DUKE POWER COMPANY
NUCLEAR PRODUCTION DEPARTMENT
P.O. BOX 33189, 422 SOUTH CHURCH STREET
CHARLOTTE, N.C. 28242
(704) 373-4011

Subject: Catawba Brochure Revision

Attached please find a first draft copy of the Catawba brochure. The form it is provided in here will change to a brochure version when put into a final draft, but for now this is a more expedient method for review. This brochure is different from that used at Oconee and McGuire to date, and is an attempt to lower the reading grade level as well as to include all NRC/FEMA required information. We intend to incorporate similar changes to the Oconee and McGuire brochures based on our experience with Catawba.

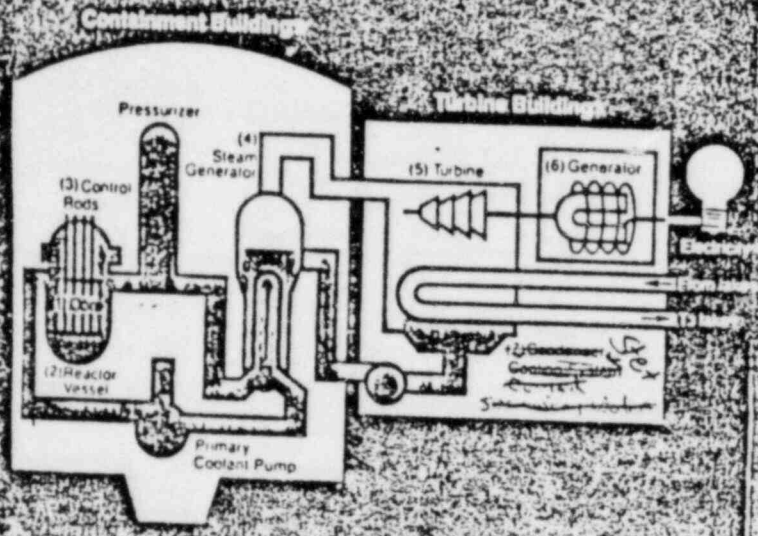
The Catawba Nuclear Station is a pressurized water reactor. It has ~~three~~^{two} oil completely separate water systems. (Illustrated on the diagram by different colors.)

X Can
for nuclear plant

Illustration B

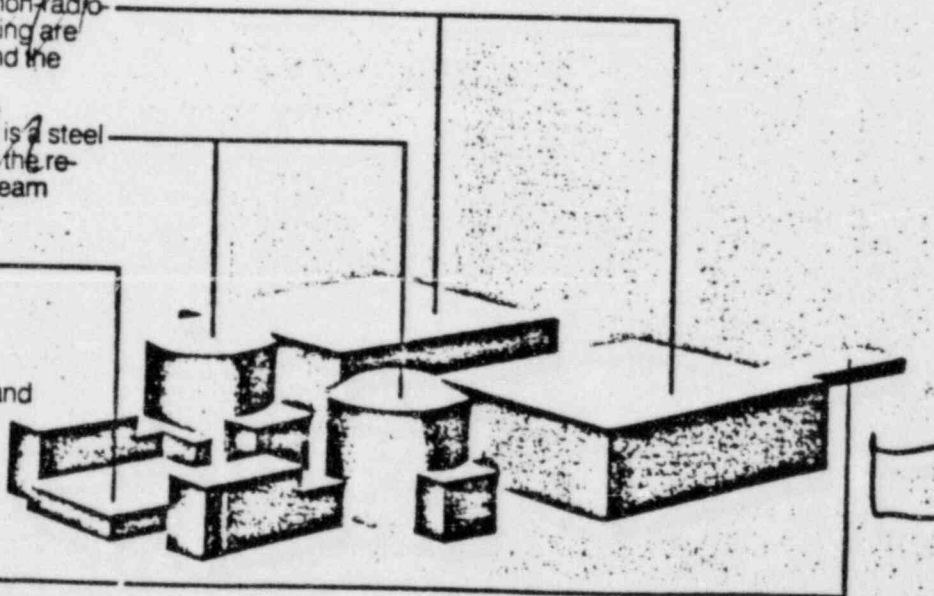
Star positioning is accurate for at alpha

Catawba Nuclear Station

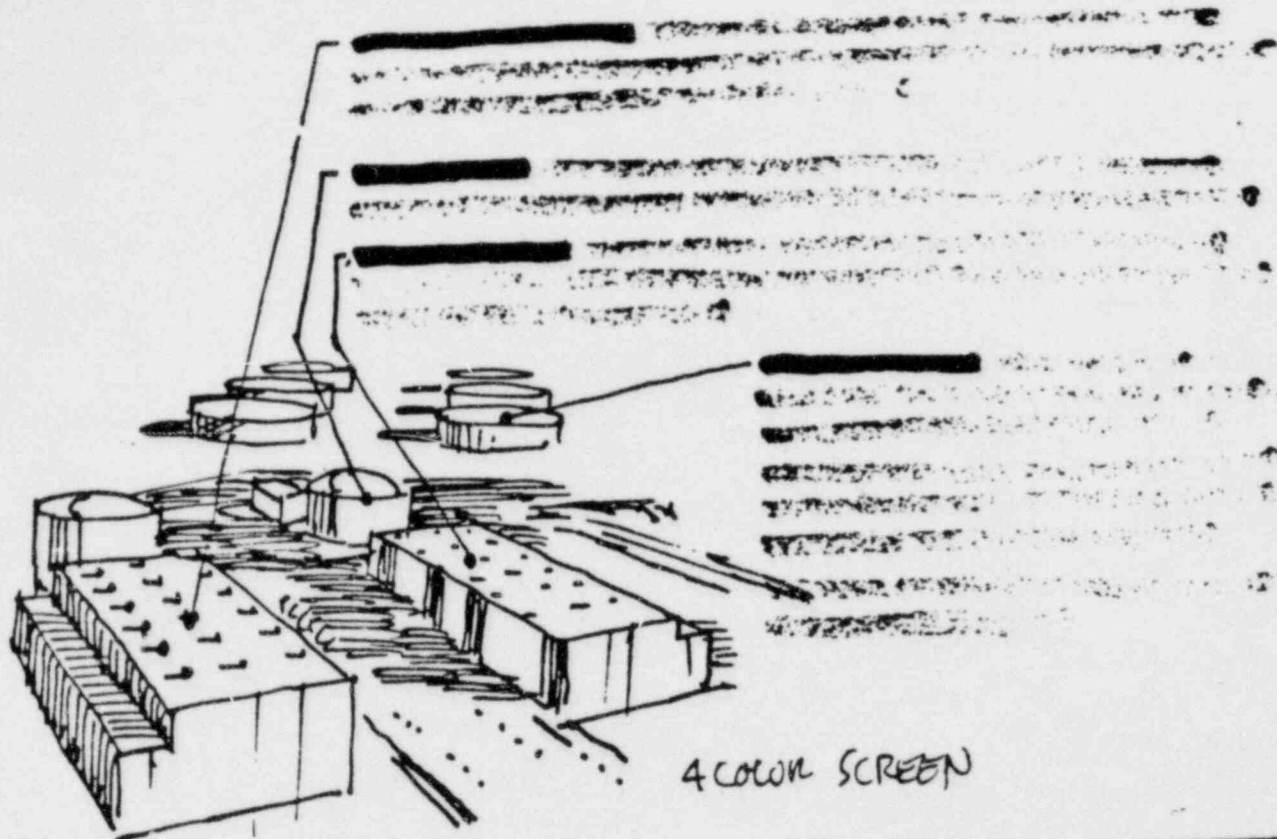
Jane - I'm unclear
on the copy to go
here. The copy you
gave me with other
material was Xed
out — ^{see} S attached
